Questions raised by BZA members at meeting of 5/26.

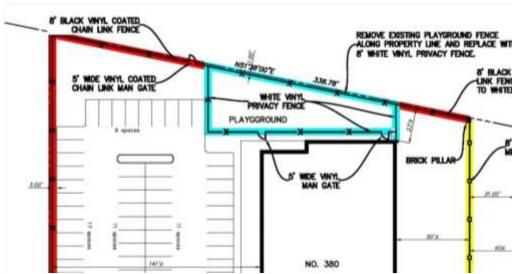
1. What is the reason for fence with 100% opacity. Won't this create a dangerous condition?

The only place the fence with 100% opacity will be used is around the playground as shown below:

This is appropriate so that it will deter individuals observing children at play in the playground area. When children are using the playground, a staff member will be in attendance.
